Maritime Electric Company Ltd.
Charlottetown, PE

133546898S301
Borden Substation and Cape Tormentine
Riser Station Construction
Request for Tender 2016-18

This addendum shall form part of the contract for the Request for Tender 2016-18 (Stantec Specification No. 133546898S301), and will alter and take precedence over any provisions of which this addendum is in conflict.

Nimitys / Benämning / Title: THREE-PHASE OIL-IMMERSED SHUNT REACTOR

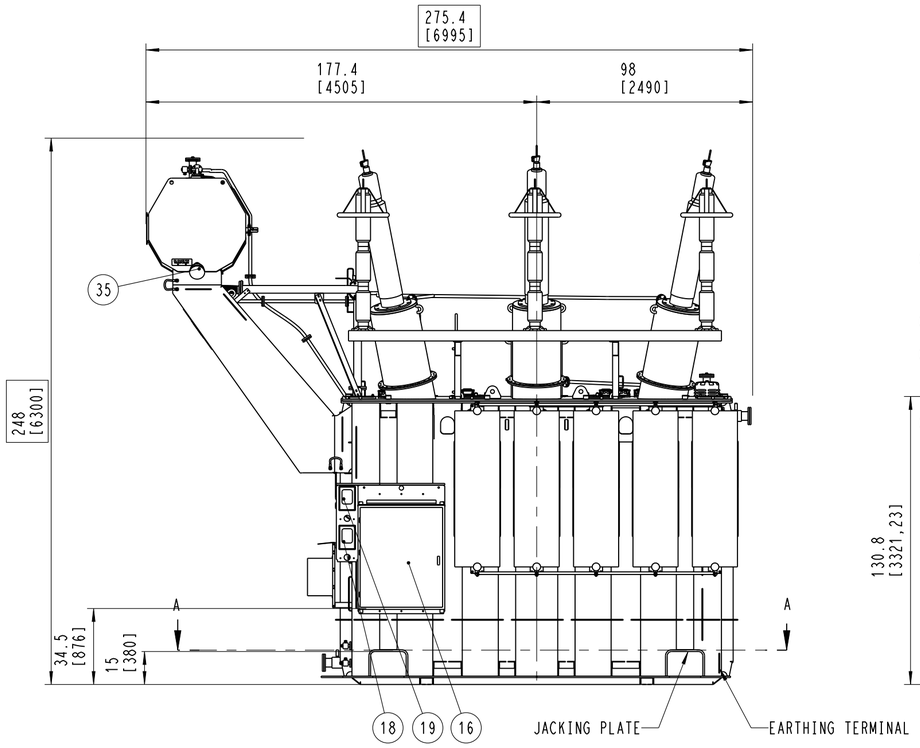
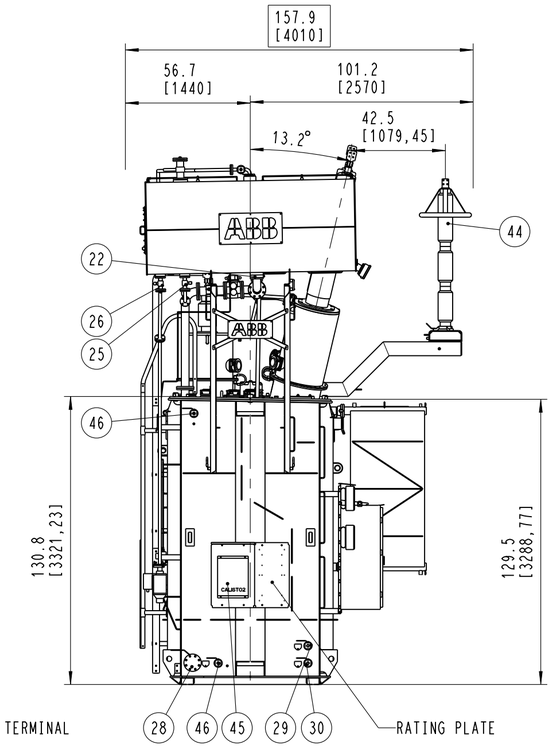
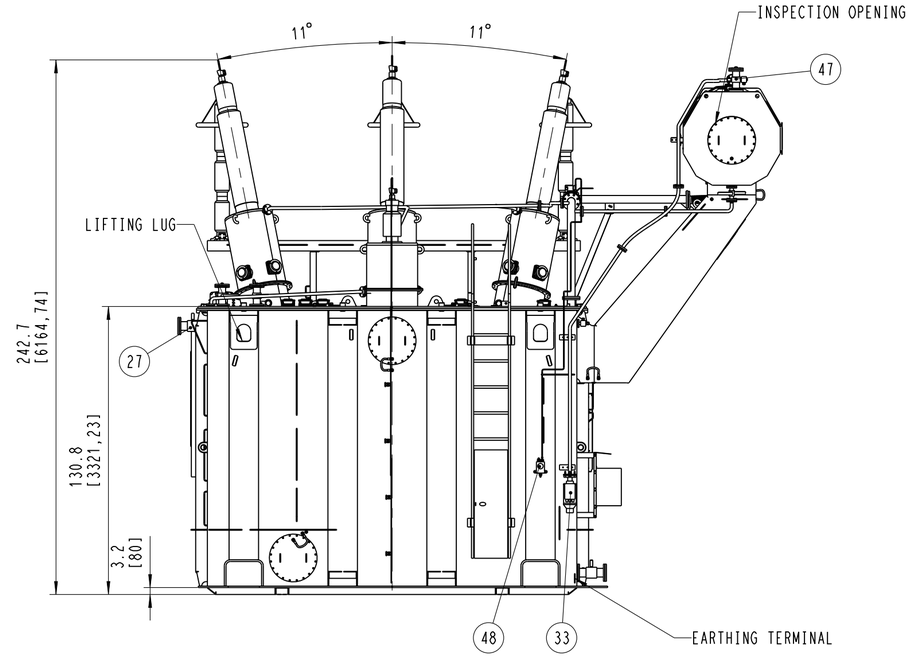
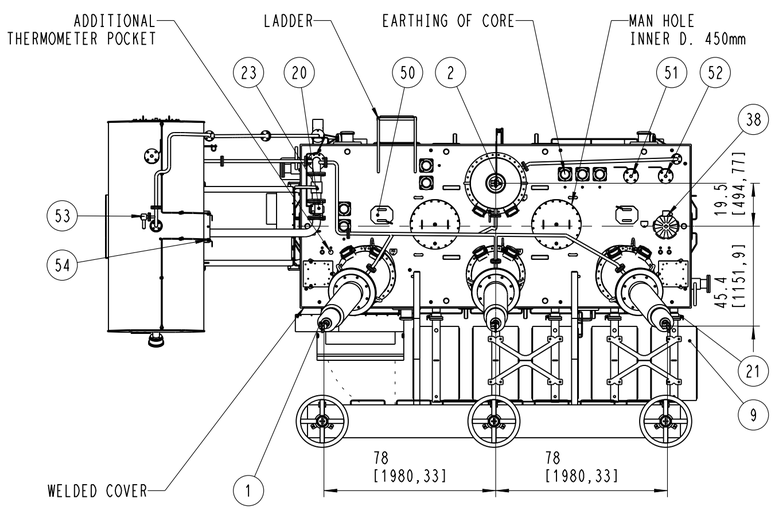
10. <u>Clarification - Reactors</u>

The Reactors will be delivered to site. The Contractor is responsible for receiving, inspecting, off-loading, and placing the Reactors on their associated pads. The Contractor is responsible to dress the reactors (install bushings & lightning arrestors). Oil top-up is not required. General arrangement drawings are attached for information.
